Groundwater Application Review Summary Form

Application # G- 18392

GW Reviewer Grayson Fish Date Review Completed: 10/29/2024

TO: Water Rights Section Date 10/29/2024
 FROM: Groundwater Section Grayson Fish
 Reviewer's Name
 SUBJECT: Application G- 18392 Supersedes review of 12/1/2017
 Date of Review(s)

Well Location Map

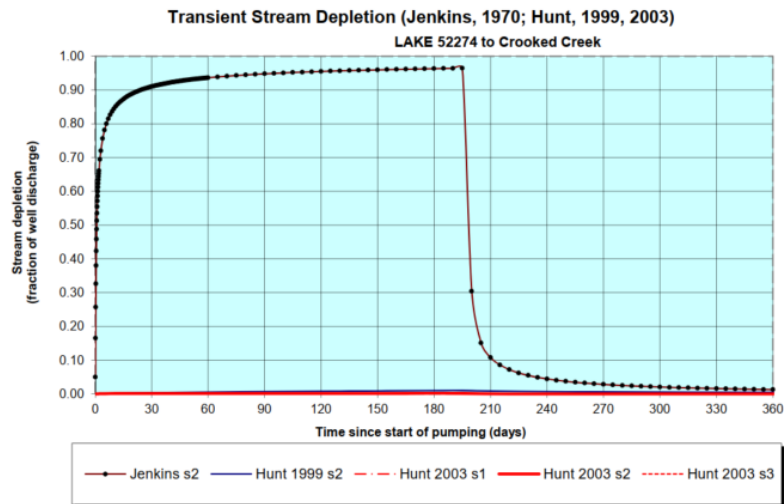
Note: the proposed POA well location is more than 0.25 miles from Crooked Creek and in hydraulic connection with the creek (See section C).

Available data indicates Crooked Creek is a perennial creek; groundwater in the area is unconfined and hydraulically connected to surface water; and the distance from the proposed POA well to the creek is more than 0.25 miles (more than 1,320 feet). Consequently under OAR 690-009, a potential for substantial interference is NOT automatically found in this review section.

The proposed POA well location is MORE than 0.25 mile from Crooked Creek.
